MANDATORY**MTL-32-03****TITLE**

LANDING GEAR - LANDING GEAR CONTROL SWITCH INSPECTION

MTL-32-03
Page 1 of 6

Figure 1. Landing Gear Control Switch Inspection (Sheet 1)

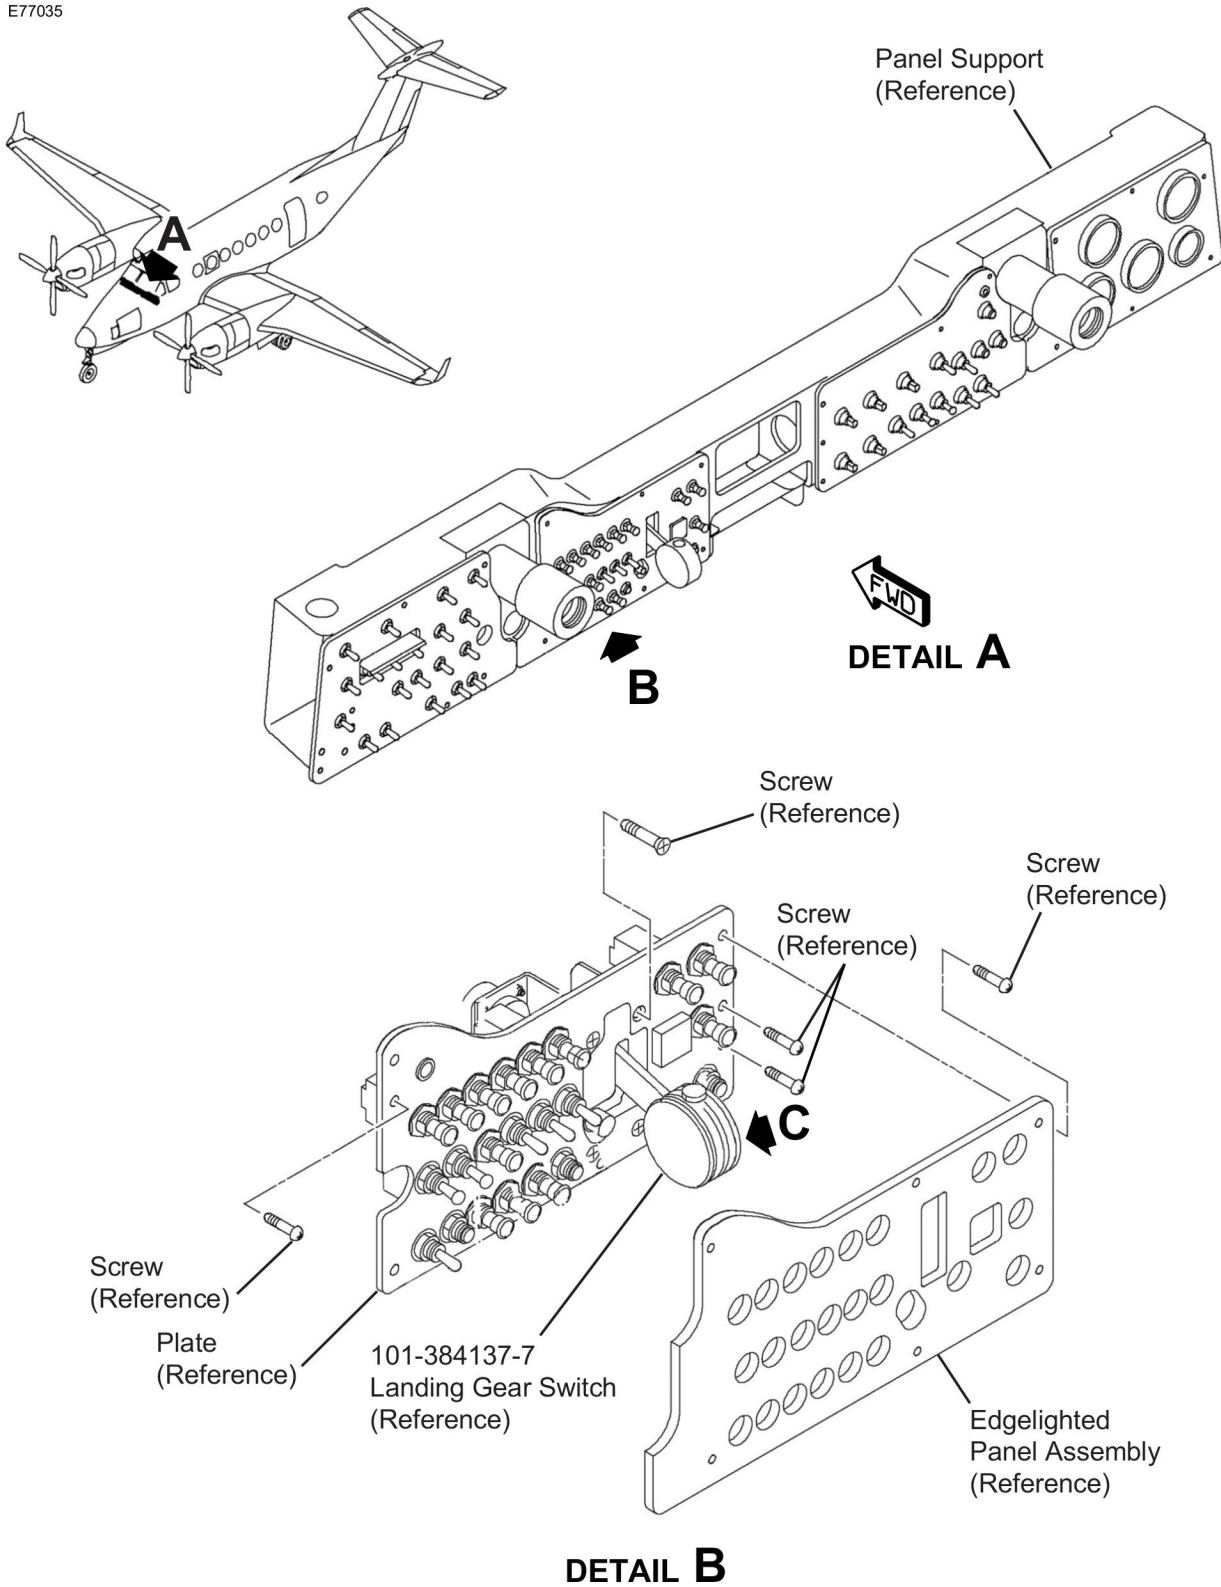
2. (Refer to Figure 1, Sheet 1.) Remove and retain the screws that attach the electroluminescent panel and plate to the panel support.
 - A. Retain the electroluminescent panel and plate.

4. (Refer to Figure 1, Sheet 1.) Remove and retain the screws that attach the 101-384137-7 Landing Gear Control Switch to the plate.
5. Pull the 101-384137-7 Landing Gear Control Switch from the instrument panel and disconnect the electrical connector.

Figure 1. Landing Gear Control Switch Inspection (Sheet 2)

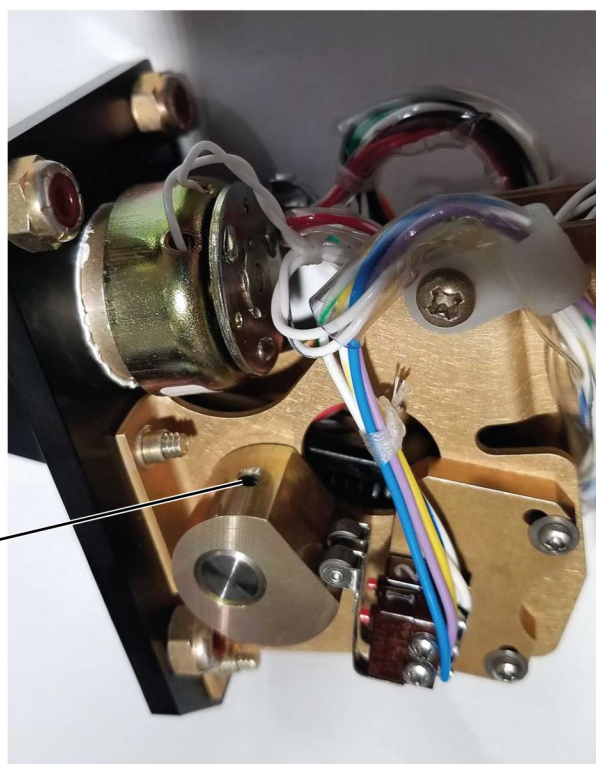
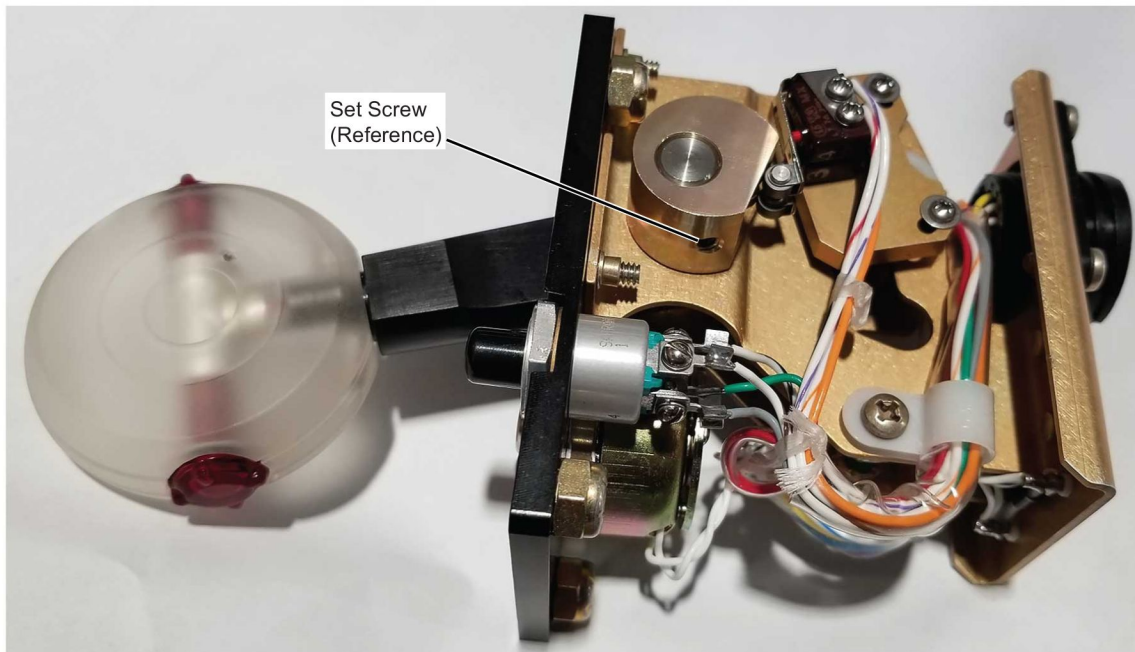
6. (Refer to Figure 1, Sheet 2.) Do a visual inspection of the set screw in the 101-384137-7 Landing Gear Control Switch cam.
 - A. If evidence of adhesive, (such as Loctite 242 thread locker) is visible in the set screw, go to Step 6.

- B. If no evidence of adhesive, (such as Loctite 242 thread locker) is visible, do as follows:
 - (1) Hold or lock the cam in place prior to set screw removal.

- (2) Remove the set screw from the cam.
 - (3) Apply a drop of U074062 (Loctite 242, thread locker) Adhesive to the threads of the set screw.
 - (4) Install the set screw in the cam.
